**Aerospace
Systems Division**

**Reliability Failure Mode, Effects,
and Criticality Analysis**

Addendum 1; HFE

ATM501

FIGURE 1

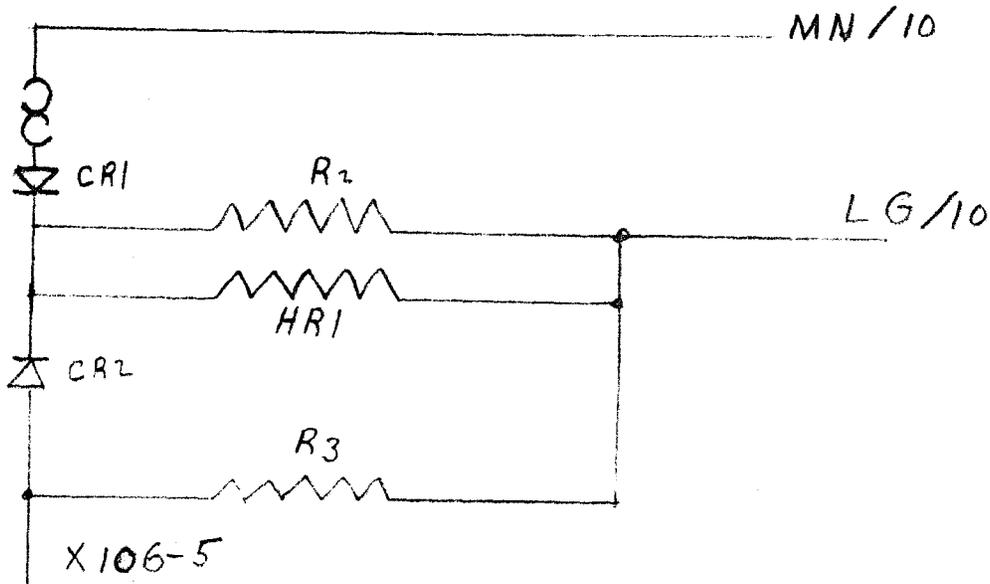
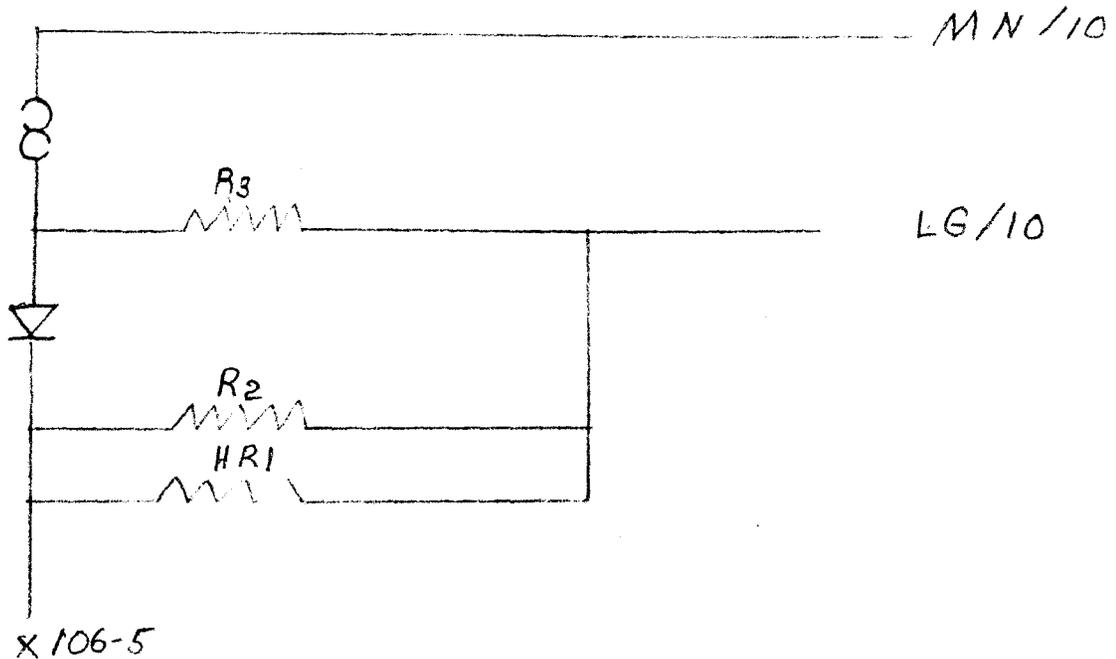
- II. CRD 60439: This CRD changed the configuration of the P-44 terminal board and effected a changed in the number of the same to P-74, (see Figure 1 for change). This circuit change deleted one diode which was a redundant inhibit to a low voltage condition on the survival power supply. The change was to assure adequate thermal control of off equatorial HFE. Other changes were slight adjustment in the linearizing resistors. The reliability is effected upward by the deletion of one diode. The effect is not significant on the over-all reliability.

FIGURE 2

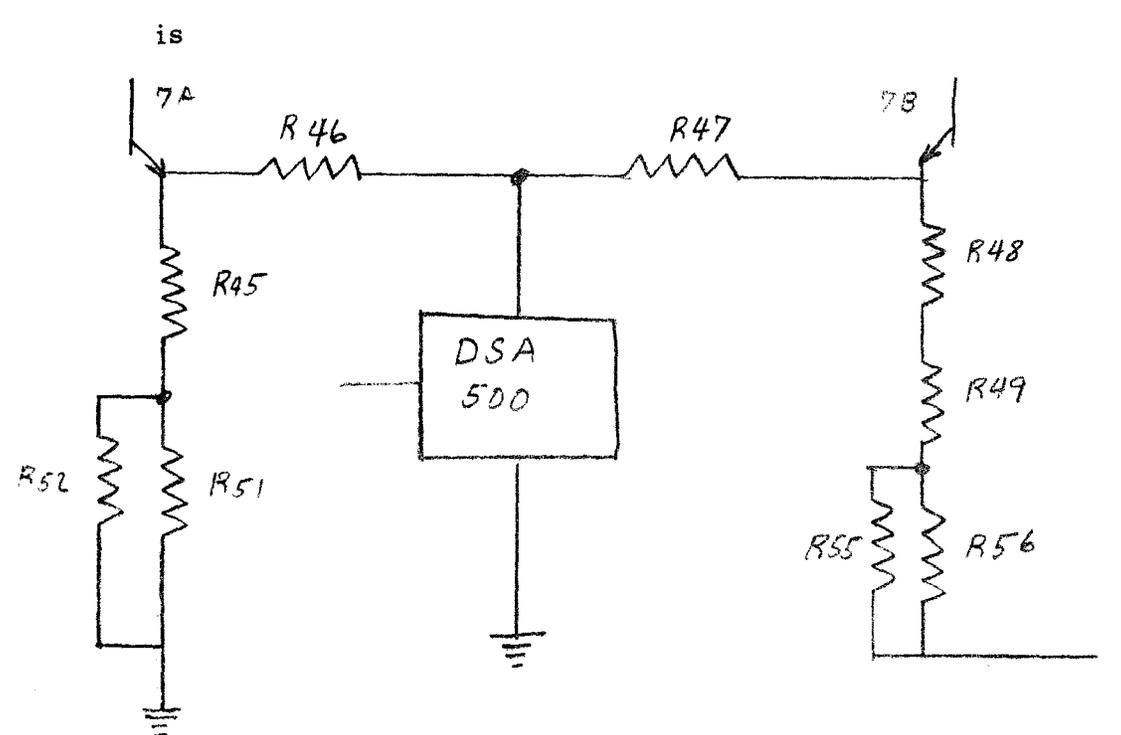
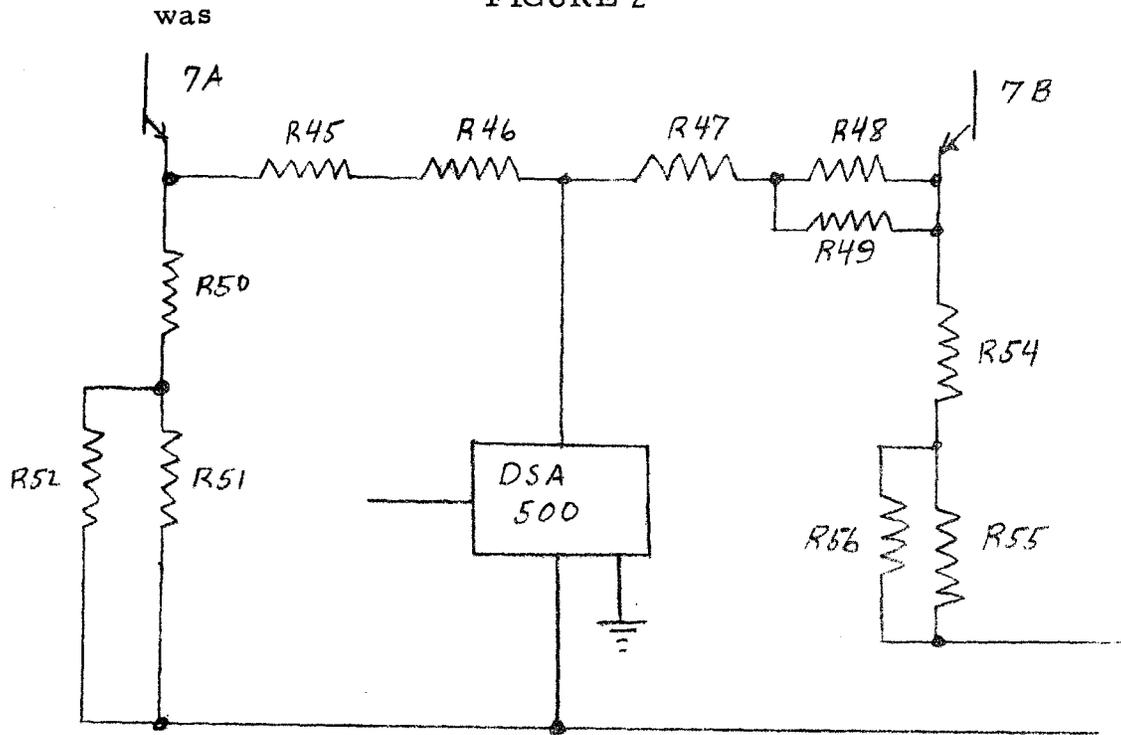
- III. CRD 60438: This CRD effects the data amplifier and allows substitution of part for non-available items and to improve component mounting methods to avoid unit damage. See Figure 2. The effect on reliability is upward since the new design deletes one resistor. Q7 was also changed from a 2N4042 to 2N 4044; this not effecting the reliability either up or down. The effect is not significant on the over-all reliability.
